PART B – AEIS

19. NOISE AND VIBRATION

Figure 19-1 – Revised Figure 19-4: Distance required to dissipate airblast overpressure for varying explosive charge mass and site constant (Ka)

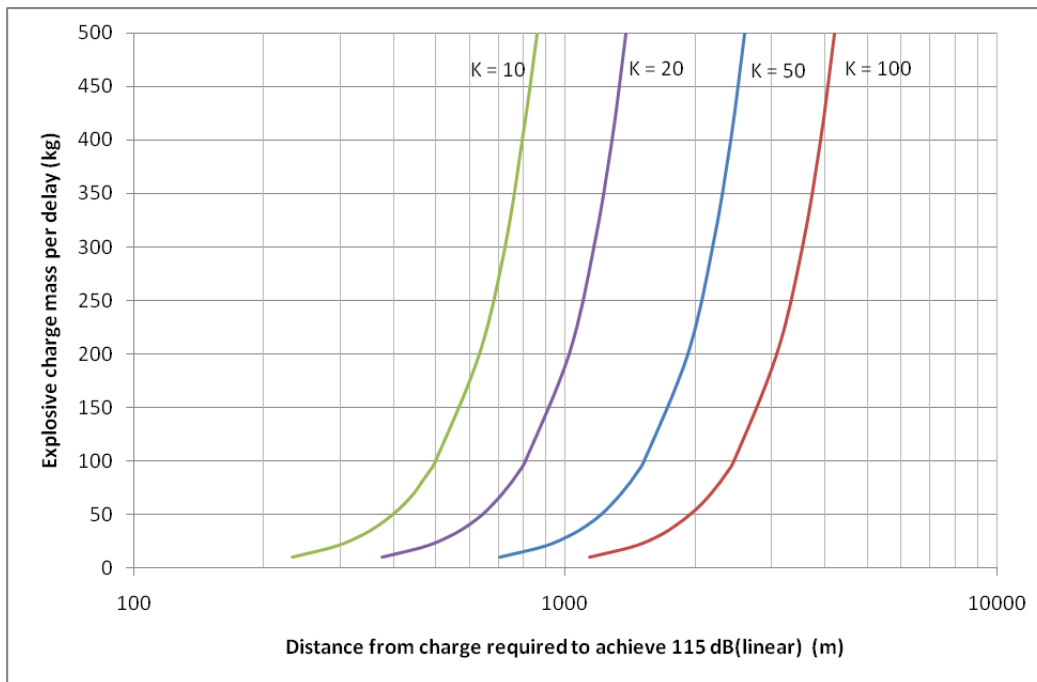
A submitter requested the revision of the graphical presentation of mass of explosives displayed in Figure 19-4 of the EIS. Figure 19-4 was used to determine the charge mass that might cause an exceedence of the guideline at the nearest sensitive receiver. This procedure was used because the actual charge mass to be used would not be confirmed until a contractor was appointed. The accompanying text noted that the resultant charge mass was much greater than any charge mass likely to be used.

A site constant (K_a) refers to the level of constraint of the charge, and it generally has a value of 10 to 100 for confined blast hole charges. The values of “ K_a ” used for the calculations are the values recommended in the Australian Standard (AS2187.2 – 2006) that are deemed to cover the range of ground propagation conditions usually encountered at most sites. Rock/soil conditions are highly variable from site to site and there are literally an infinite number of conditions that can exist ranging from “normal” vibration propagation in a hard uniform material or any variant involving augmentation or attenuation from the “normal” condition. These variations are caused by soil layering (harder or softer) above or below the rock layer, fractures and fault lines in the rock strata and varying water table height, all of which can modify the vibration energy radiating from the blast. A higher site constant (K_a) subsequently requires a higher buffer distance.

Figure 19-4 (EIS) has been revised and is represented in **Figure 19-1**. The figure shows how the distance required to dissipate airblast overpressure varies with blast size and site constant (K_a). This figure illustrates that, for even the largest likely construction blast of 500 kg/delay, the airblast overpressure goal (115 dBL) is met at a distance of about 900m if $K_a = 10$ and just over 4km if $K_a = 100$. The figure also shows that, as the explosive charge/delay reduces, the distance required for the airblast overpressure to drop below the nominated goal also reduces.

When a largest likely construction blast of 500 kg/delay is considered, the methods specified in AS2187.2 – 2006 predict that ground vibration levels will be below the 5 mm/s peak particle velocity limit at 650m for 50% of all blasts and less than 1.8km for 95% of all blasts. Therefore, the airblast overpressure criteria will be the main factor in setting buffer distances.

Given the nearest sensitive receiver is at 6km from the blast site these results demonstrate that there is negligible risk of damage from even the largest likely construction blast.
